PERFORMANCE BULLETIN

**Pentair**
Water Treatment

March 19, 2003

9100 Updates Compared To The 9000

Screw

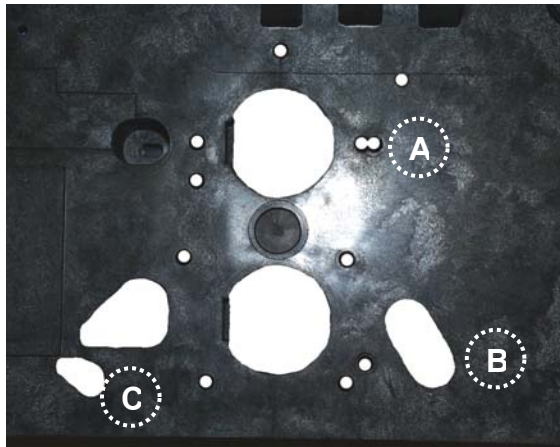
The 14202 screw that holds the connecting yoke assembly for the 9000 2nd tank adapter has been shortened and changed to 14202-01. If you do not use the new 14202-01 screw in a 9100, the screw will not tighten the 13255 clip. Performance Bulletin # 387 will also explain the change.

Old

14202
8-32 x 3/8"

New

14202-01
8-32 x 5/16"

Backplate

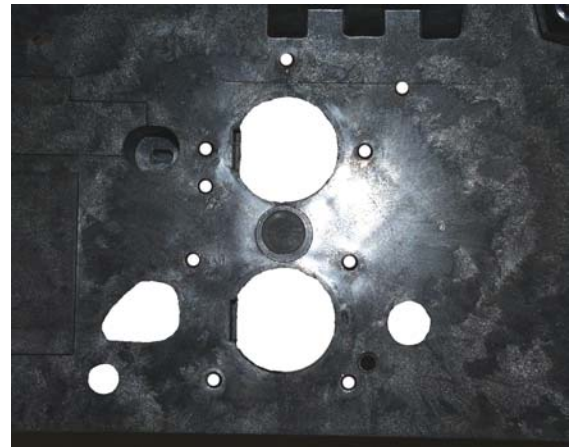
The 9000 backplate has been changed to accommodate the screw location for connecting to the valve body, 2nd tank and meter connection for the 9100. If you have an older backplate (powerhead) in stock for a 9000, this will not work on a 9100. The backplate change was in production in late October of 2002.

- A. Extra screw hole for connecting to 9100-valve body.
- B. Larger opening for locating screw for 2nd tank connection.
- C. Larger opening for meter screw.

Inlet/Outlet

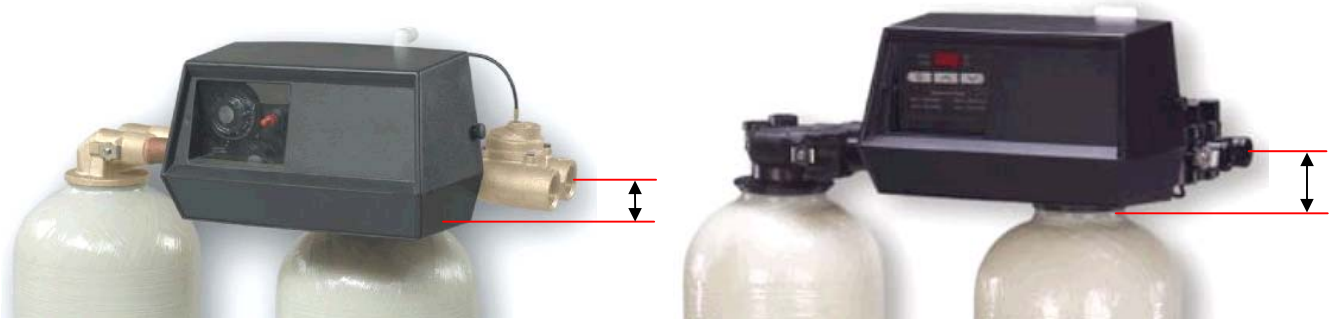
The 9100 control valve inlet/outlet will be about 3/4" higher above the tank than a 9000 control valve. If you were to convert an existing 9000 to a 9100, plumbing changes may be required.

Injector Drain O-ring

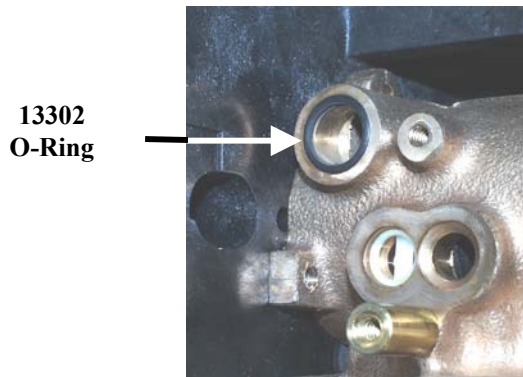
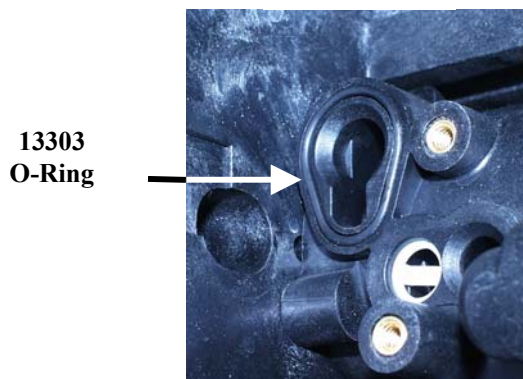
The 9100 injector drain o-ring is larger than the o-ring on the 9000 control valve. When ordering the 60385-XXXX injector assembly, both drain o-rings will be included with the assembly.
